**KAWARTHA PINE RIDGE DISTRICT SCHOOL BOARD
PUR24-072-ITT
Hampton Junior Public school Classroom Refresh**

ADDENDUM NO. 2

Add (3): Addendum No. 1, Project 24004, prepared by Barry Bryan Associates, (4 pages)

Project No.: 24004
Date: April 24, 2024
Tender No.: PUR24-072-ITT
Project: **KAWARTHA PINE RIDGE DISTRICT SCHOOL BOARD
Classroom Refresh at Hampton Jr. Public School**

HM-01

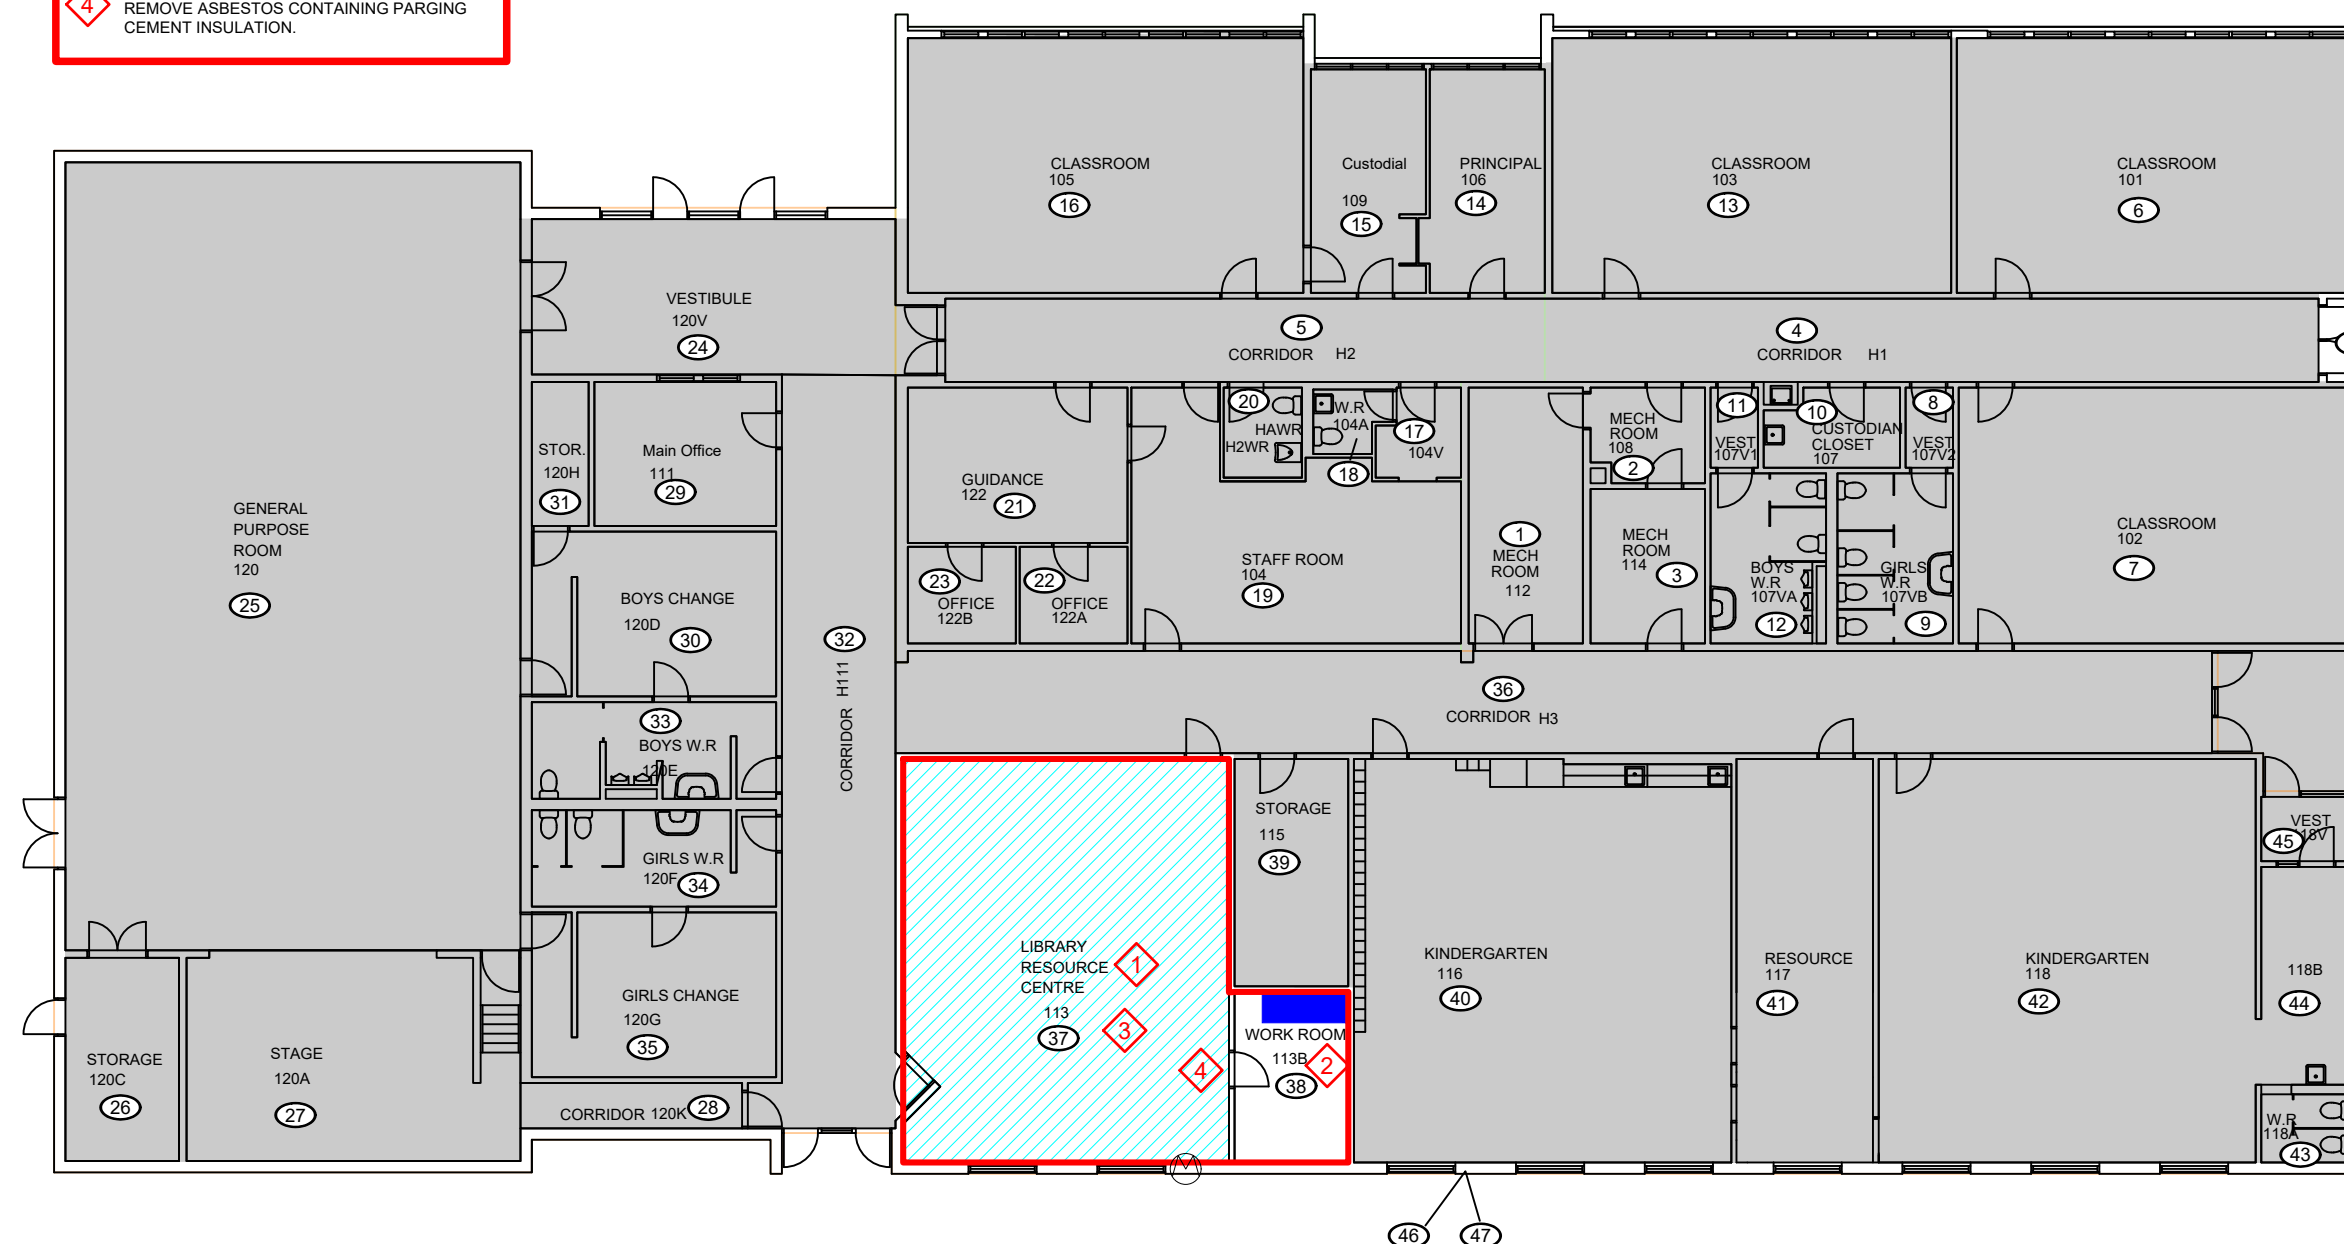
Question 1: Asbestos Scope of Work- Note 1 says to remove asbestos containing vinyl floor tile and levelling compound. The room currently has carpet installed. Please confirm that the abatement contractors are to remove carpet, floor tile and levelling compound complete as it will all be attached.

- .1 DRAWING HM-01 – Scope of Work
 - .1 Revise drawing note 1 to state removal of carpet.

Answer 1: The leveling compound was found in 2 out of 3 samples of the carpet mastic. These two samples came back as non-asbestos. Unfortunately, we need three samples to prove something is not asbestos containing. Similarly, to how we plan to sample the tack board mastics on the day that the school is empty, and we can start doing that type of demolition we would also like to sample the leveling compound to determine if it is non-asbestos. We would send the samples on 24 hours turn around hopefully getting results before abatement is scheduled to start. The thought is that by getting pricing now for having it removed as asbestos there is budget allocated for the removal and disposal of asbestos. Should the samples come back as non-asbestos disposal would be less, you may not need to pay the abatement crew for as much work, and there would be a cost savings since regular waste is less than asbestos waste disposal.

- 1 USING TYPE 1 PROCEDURES, REMOVE ASBESTOS CONTAINING LEVELING COMPOUND AND CARPET.
- 2 USING TYPE 1 PROCEDURES, REMOVE SINKS WITH ASBESTOS CONTAINING MASTICS.
- 3 USING TYPE 1 PROCEDURES, REMOVE TACKBOARDS AND ASSOCIATED ASBESTOS CONTAINING MASTICS.
- 4 USING TYPE 2 GLOVE BAG PROCEDURES, REMOVE ASBESTOS CONTAINING PARGING CEMENT INSULATION.
